Re: FirstLight Hydro Generating Company, Turners Falls Hydroelectric Project (FERC No. 1889) and Northfield Mountain Pumped Storage Project (FERC No. 2485).

Response to Comments re: Study 3.3.19-Continue to Evaluate the Use of an Ultrasound Array to Facilitate Upstream Movement to Turners Falls Dam by Avoiding Cabot Station Tailrace

Comments on First Light Proposed 2018 Ultrasound Shad Study

Connecticut River Conservancy Comments on FirstLight's Study Plan for 2018 addition to Study 3.3.19: Evaluate the Use of an Ultrasound Array to Facilitate Upstream Movement to Turners Falls Dam by Avoiding Cabot Station Tailrace

Figure 1-1: Proposed locations of the transducers for the 2018 Study1-4

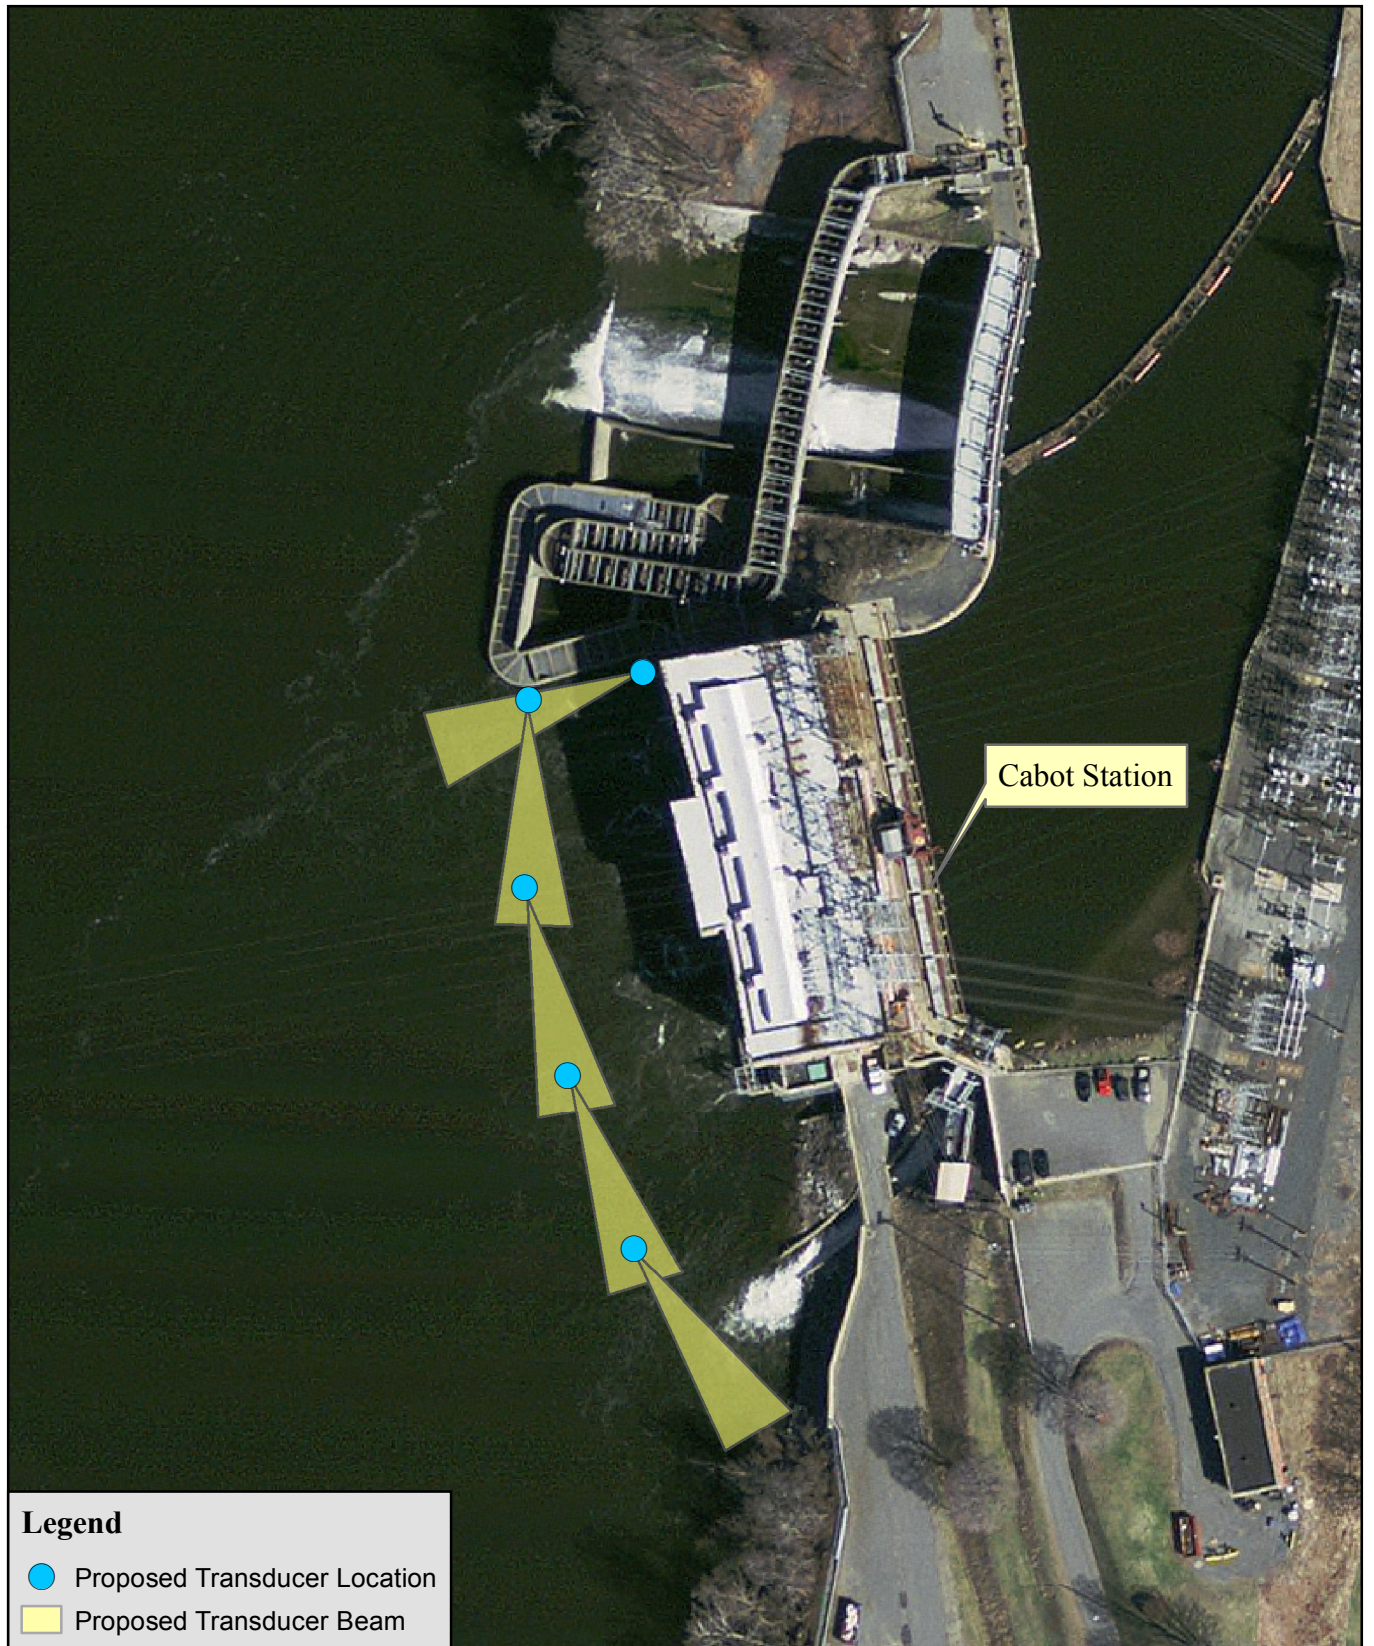
The plan should describe how the placement of transducers will consider the location and volume of entrained air so as to avoid entrained air.

The transducer locations for the 2018 study have been selected to minimize the effects of turbine discharge air entrainment on the transmission of ultrasound in the study area to the extent possible. Sound measurements recorded after the system has been installed will determine whether a continuous sound field of sufficiently high sound pressure levels is achieved at the edge of the tailrace across its length from downstream to upstream. Sound field measurements will be made for multiple generation scenarios, to the extent possible, and the resulting data will be provided in the study report (including graphical plots showing sound pressure levels throughout tailrace area and adjacent river channel).

Figure 3.2-1: Proposed
Telemetry Sites for
Ultrasound Array Study

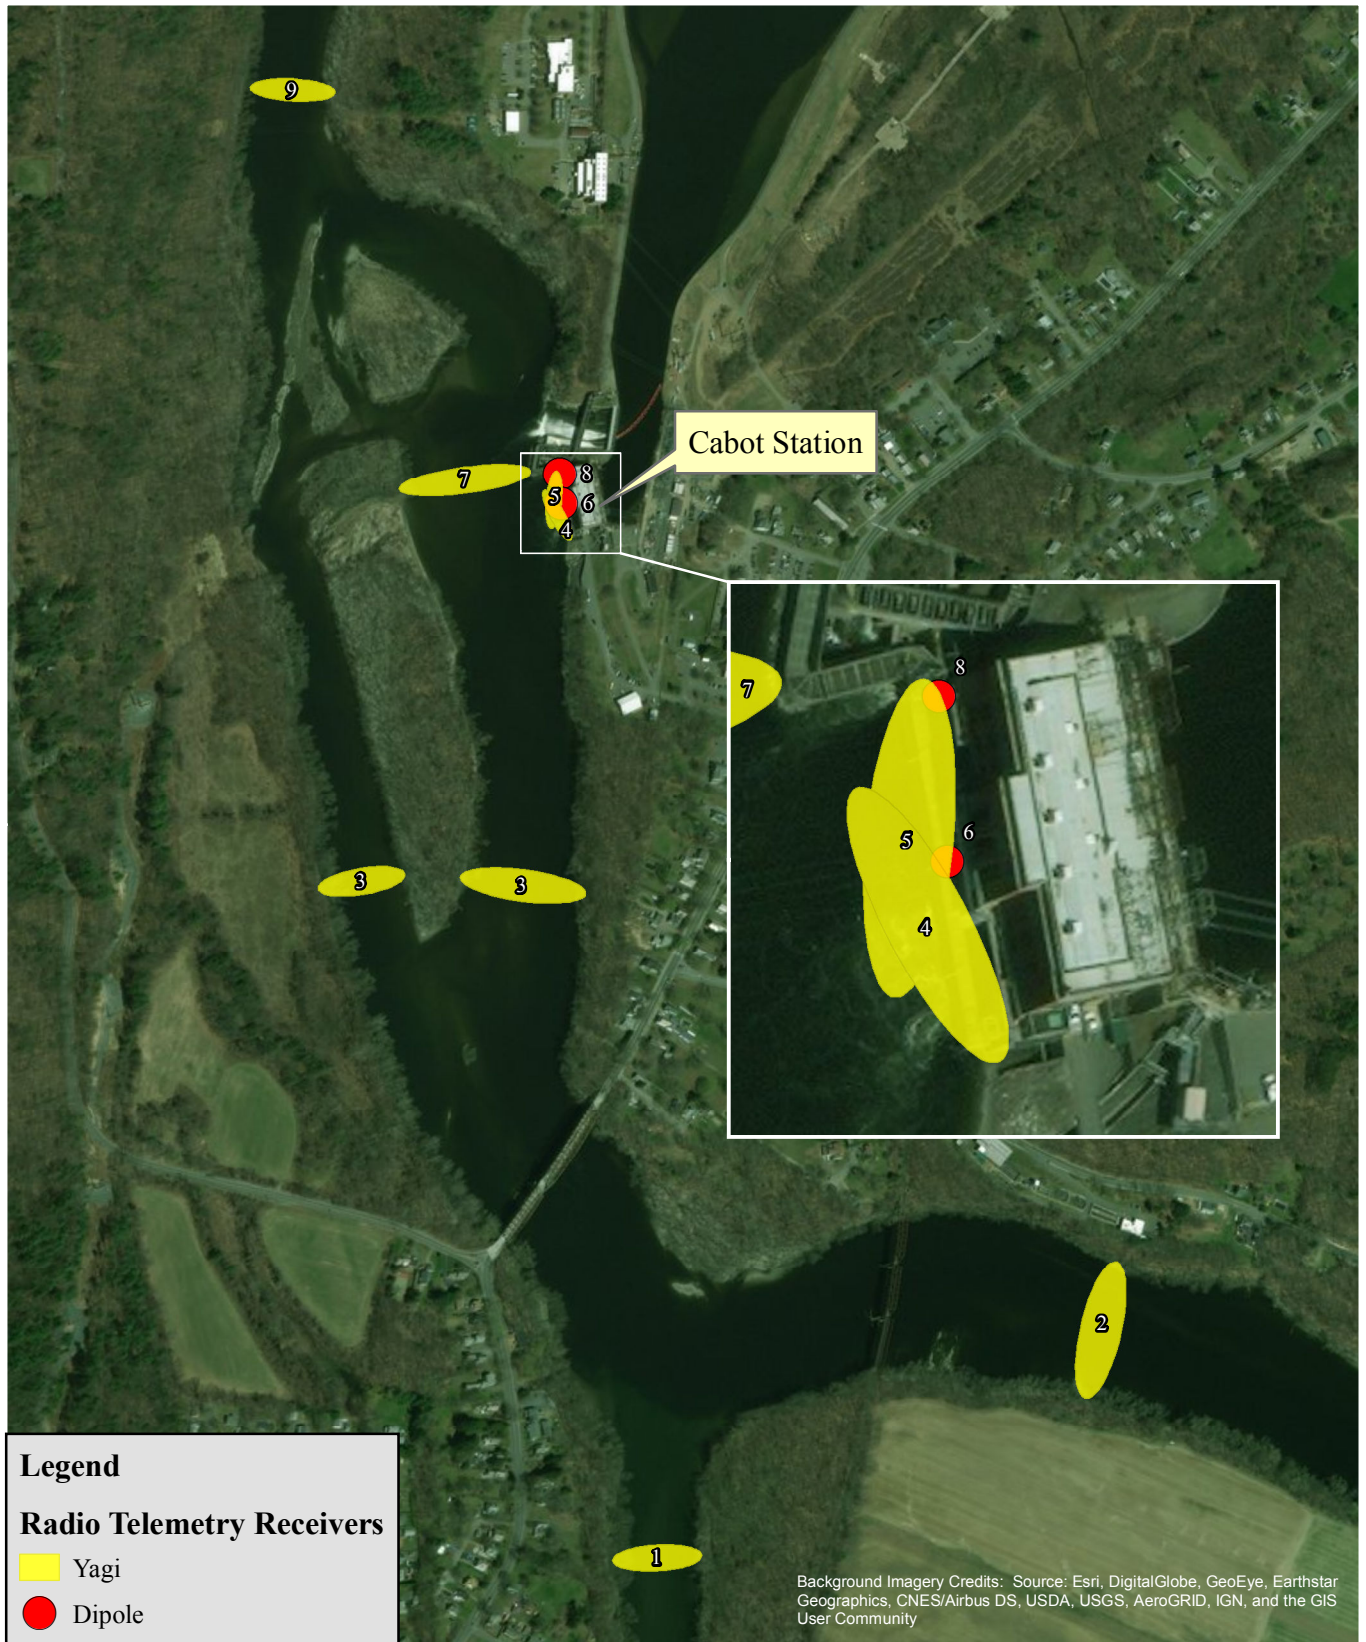
7. A potentially significant problem is that downstream receiver arrays (between receivers 3 and 8, or perhaps even between 2 and 8) might fail to accurately place the fish within the 'tailrace reach'. Successful deflection by the array will minimize retention in this entire zone. Fish within this zone will comprise the denominator from which guidance up the bypassed reach must be measured. As designed, there will be considerable uncertainty as to whether fish are in this zone or elsewhere (downstream or in the Deerfield). This will boost the Type II error rate, and reduce the sensitivity of the design

It would be in FL's interest to ensure accurate detection of departures from the 2-8 zone. The confluence of the Deerfield is also a spawning area so we strongly suggest boosting the coverage just upstream of the Deerfield confluence as a way of better identifying those fish that are actually in the tailrace reach. Therefore, we recommend adding three more receiver arrays, basically doubling locations 1, 2, and 3. These arrays must have high probability of detection on each receiver to create reliable "gates" that describe directionality of movement.

Stakeholder comments included several requests for additional stationary receivers in the study area. We agree with stakeholder comments that the detection efficiency at the Montague Wastewater Treatment Plant was less than optimal during previous studies. Instead of adding an additional receiver on the other side of the river as suggested, we plan to move this receiver (Station 2) downstream between Third and Fourth Islands where the river is narrower and shallower to optimize our ability to detect all the fish that enter and exit the study area. We will also add an additional receiver in the Cabot tailrace area intended to capture

the width of the river (farfield). We also plan to take measures to bolster detection probability at Stations 8¹ and 3, and ensure that they are as high as possible. We do not plan to install additional receivers on river right, (far side of the dam from the Gatehouse) since during the 2015 telemetry study only two (2) shad were detected on river right and 19 were detected on river left. Radio receiver Station 12 at the Spillway ladder was plagued with false positives from fish known to be in the Turners Falls Impoundment so we are not proposing to increase the detection range of this receiver. The Lotek receivers do employ antenna switching.

Figure 3.2-2: Proposed
Telemetry Sites for
Ultrasound Array Study

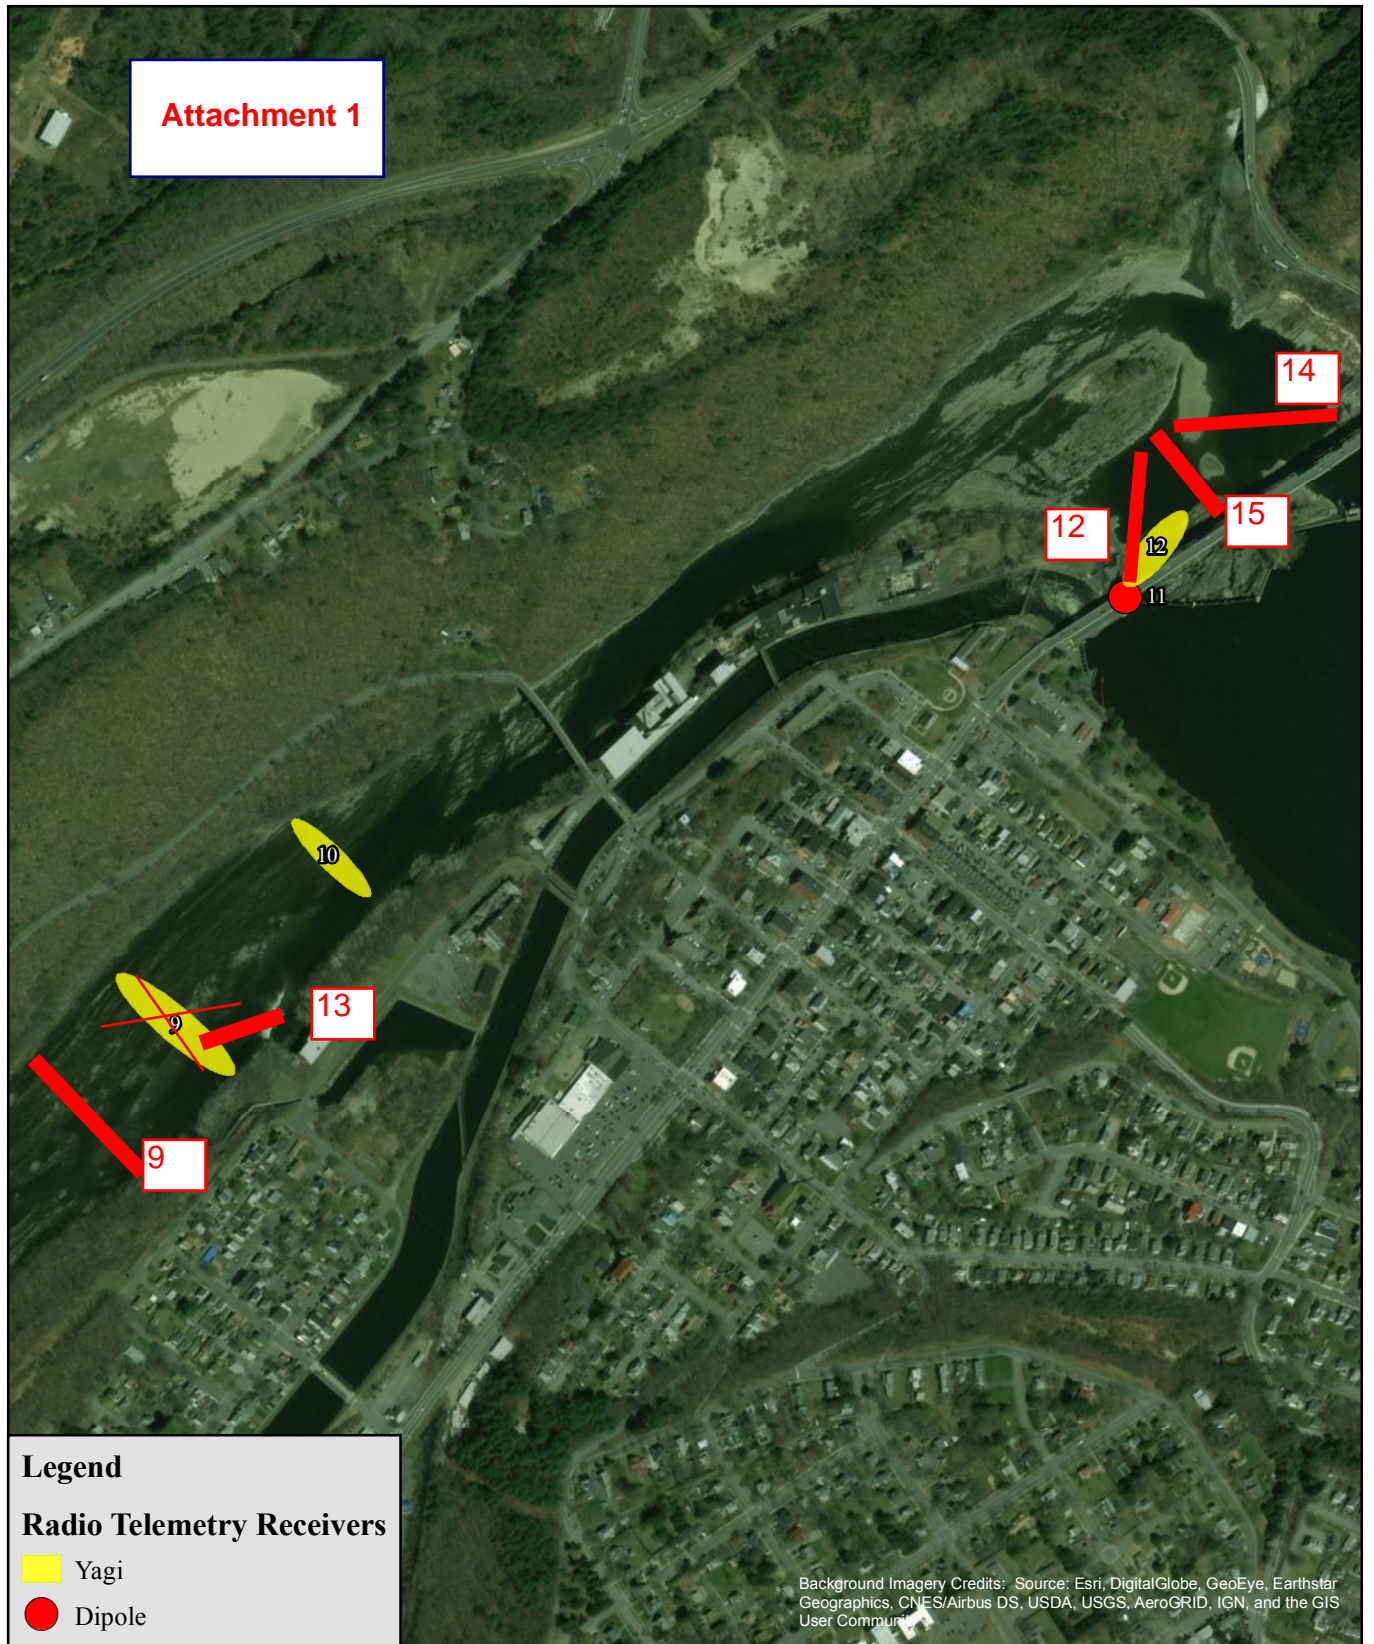
The study plan should more clearly explain antenna #6's location and the number of droppers.

Attachment 1: proposed changes to the antennas
